CITY OF OREGON CITY

CITY COMMISSION REGULAR MEETING - REVISED AGENDA

Commission Chambers, Libke Public Safety Facility, 1234 Linn Ave, Oregon City
Wednesday, September 01, 2021 at 7:00 PM

[8a.](#) AP 21-00004 and AP-21-00005: Two Appeals of Planning Files GLUA-21-00002: SP-21-00001 / LL-21-00002 for a Lot Line Adjustment and Site Plan and Design Review for a 60-Unit Residential Condominium Project on Holmes Lane - Neighborhood Association Fee Waiver Request Associated with One Appeal

Site Plan

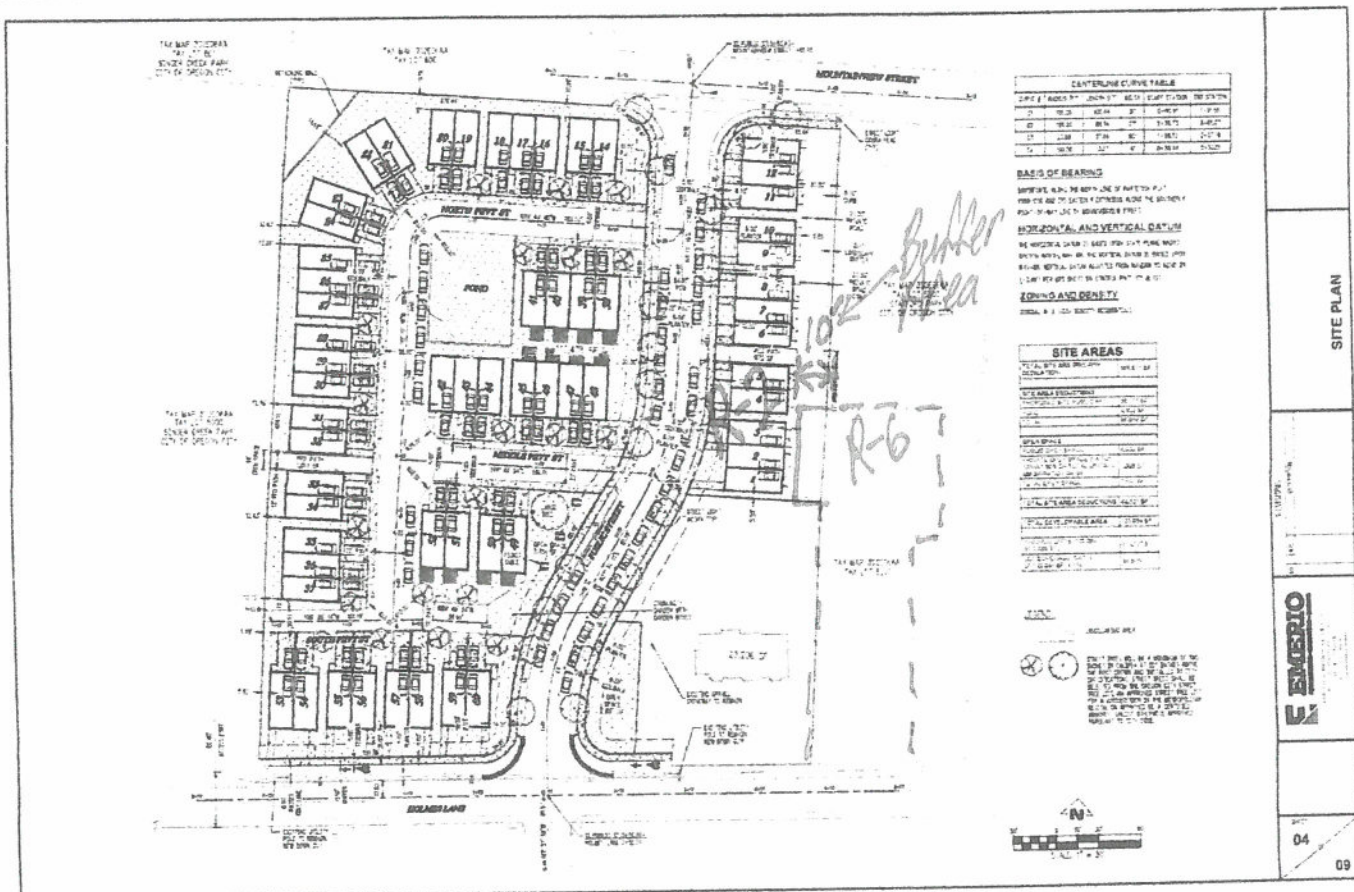
Picture shows 3 Feet from Surveyors Bench
Mark Between Fence post and Metal Fence Post.
Developers Drawing Shows a five Lane at
this point. Clearly not a 10" Buffer

Item #4 Parking. There will not be enough parking for the number of residents living in the new 60 unit project. No parking allowed in the Five Lanes. No Resident Parking in Stafford Park. No Parking on Holmes Lane. No Parking on Mountain View Street.

Site Plan

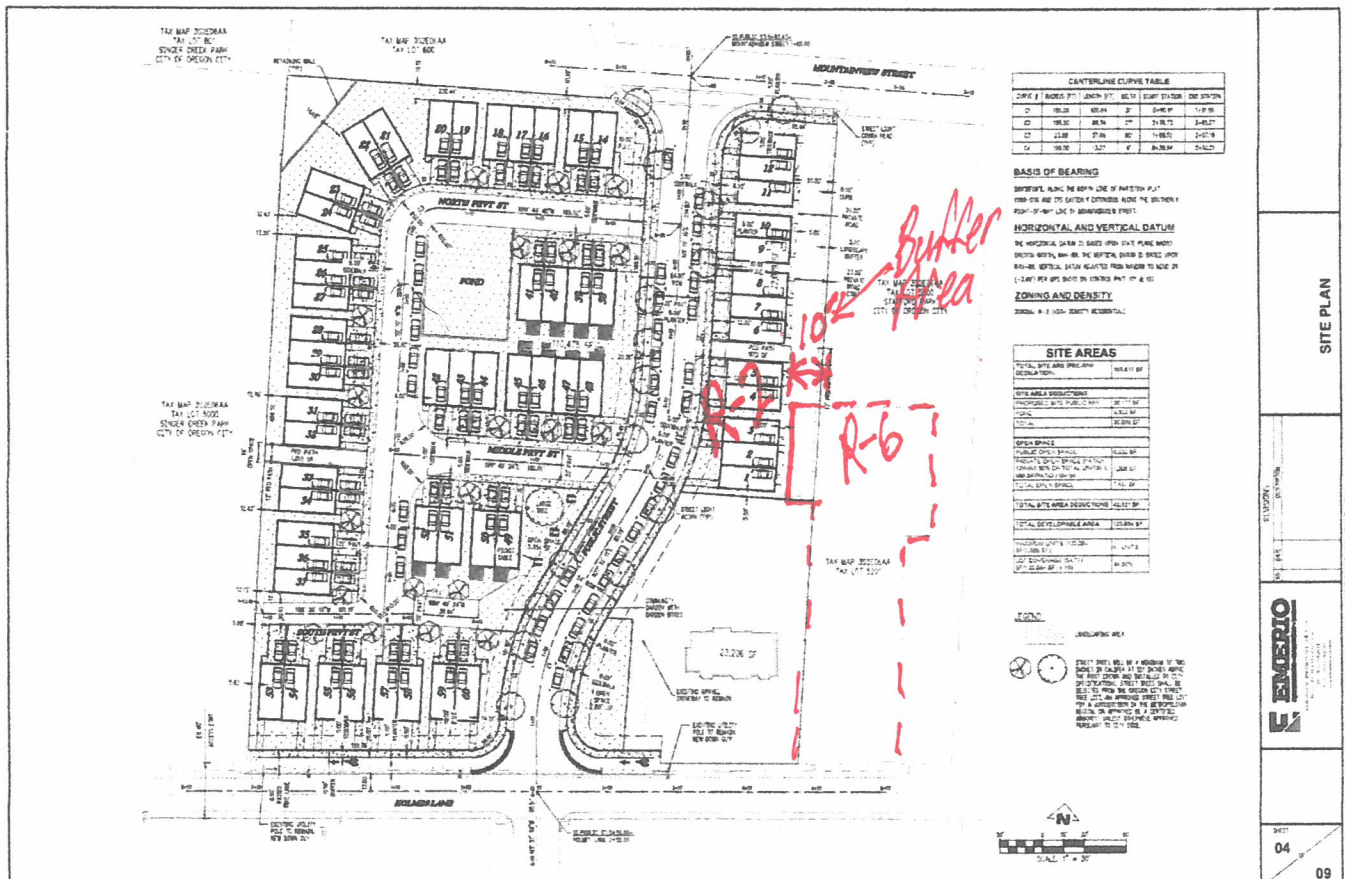
Picture shows 3 Feet from Surveyors Bench
Mark between Fence post and Metal Fence Post.
Developers Drawing Shows a 10' Buffer at
this point. Clearly not a 10' Buffer

Item #4 Parking. There will not be enough parking for the number of residents living in the new 60 unit project. No parking allowed in the Five Lanes. No Resident Parking in Stafford Park. No Parking on Holmes Lane. No Parking on Mountain View Street.

Site Plan

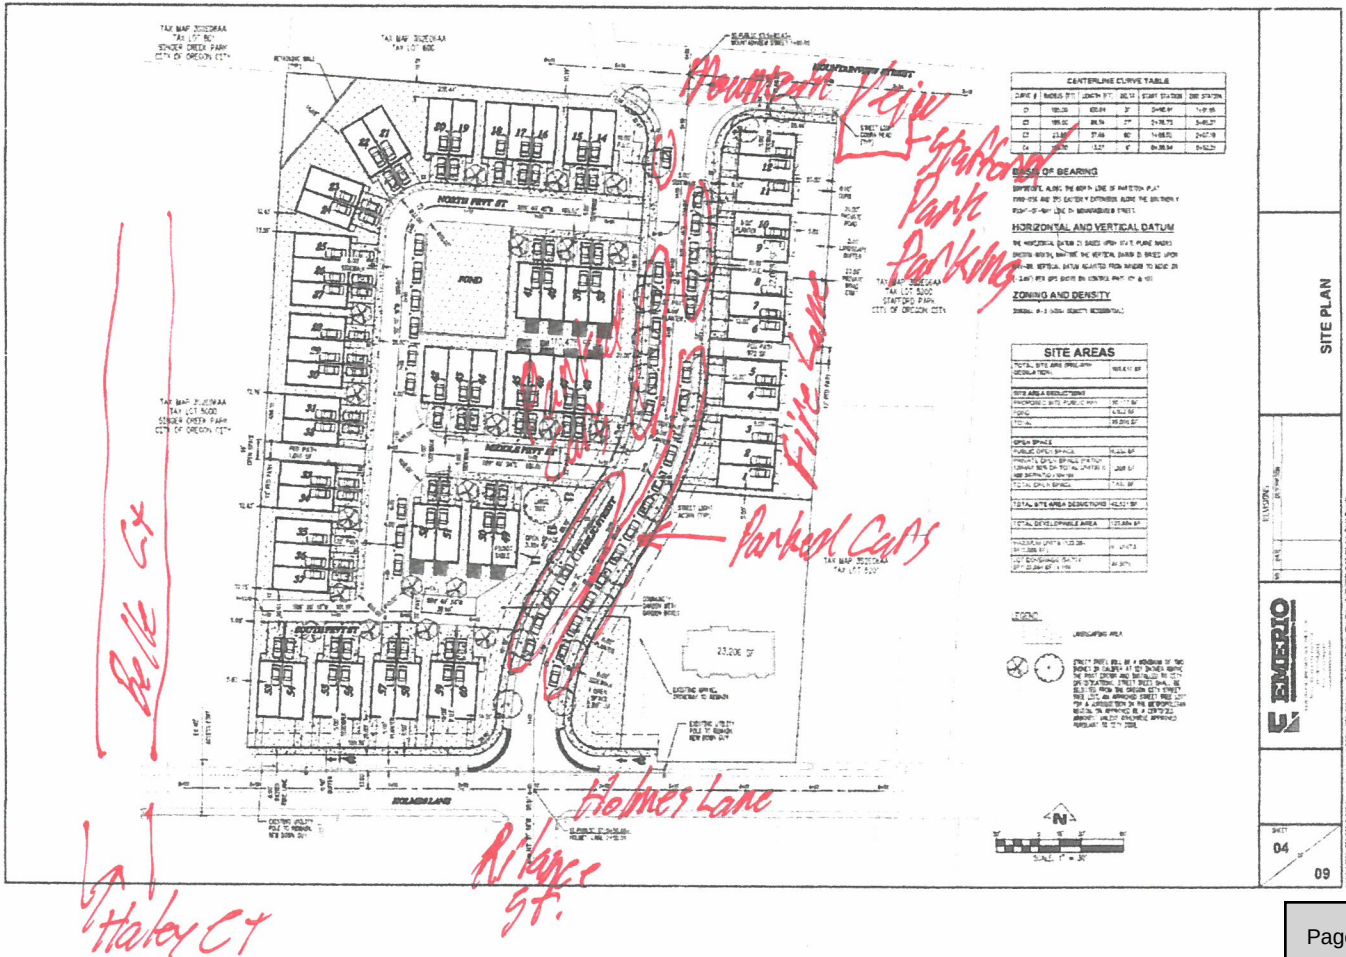
Item #5 Singer Creek and Water Collection Pond.

Will water from the new pond drain into Singer Creek? Is it Street run off? Street run off contains oil and chemicals from cars, and pesticides, herbicides, from new homes.

Site Plan

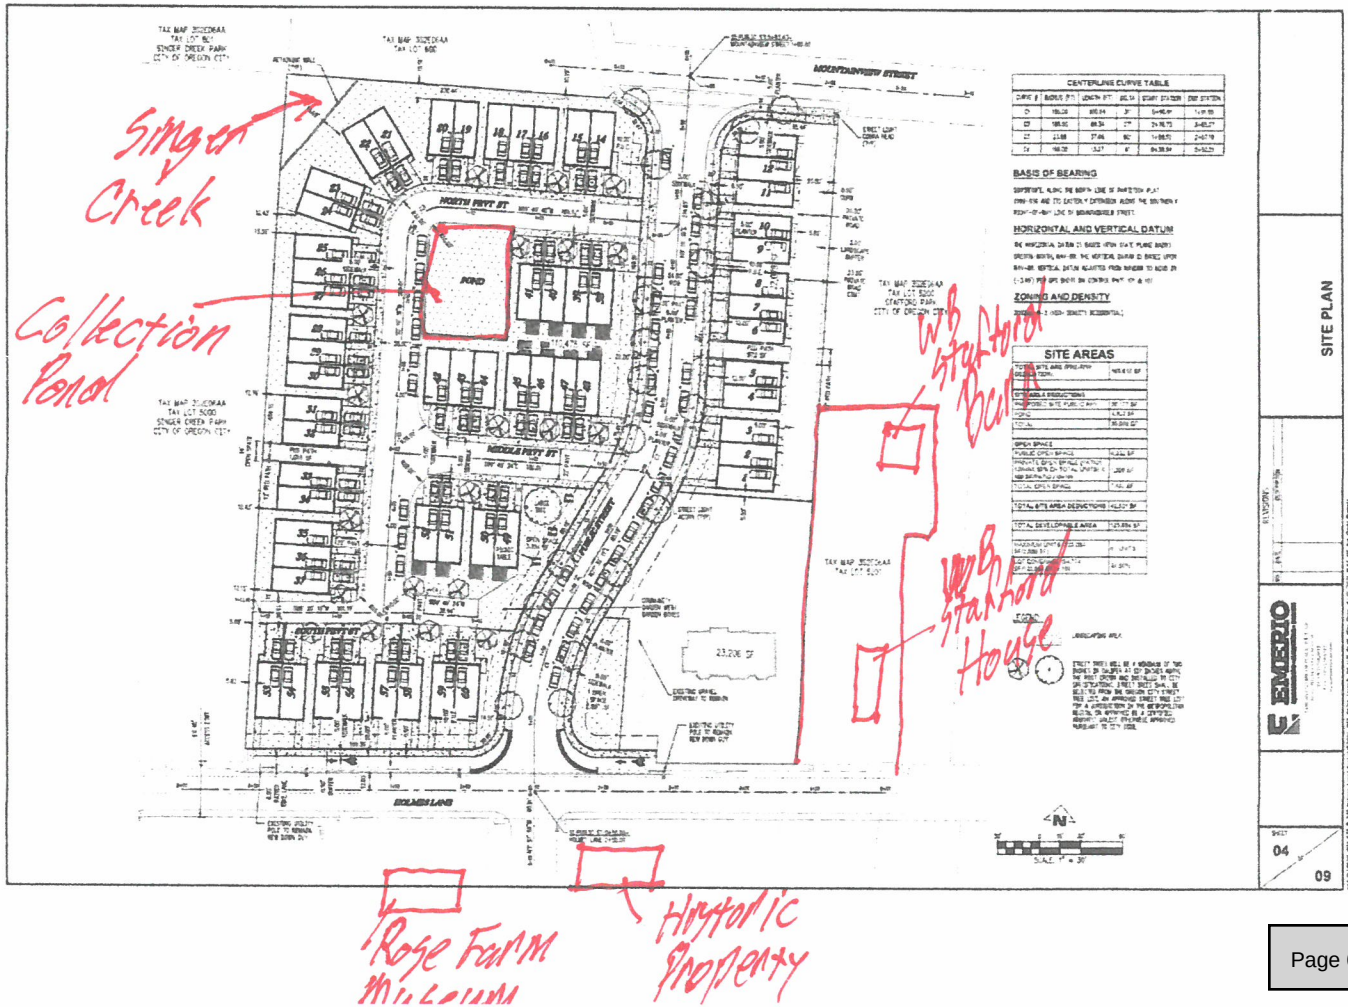
If you put the 60 unit condominiums
up you will have a lot of problems
like more wrecks, and cars killed
more speeding, using drugs, a lot
of needles, they will use the park
for a bathroom, will not be
quit more cars on ~~the~~ Mountain View
and Holmes Ln. more shootings
and cans, trash, Bottles everywhere
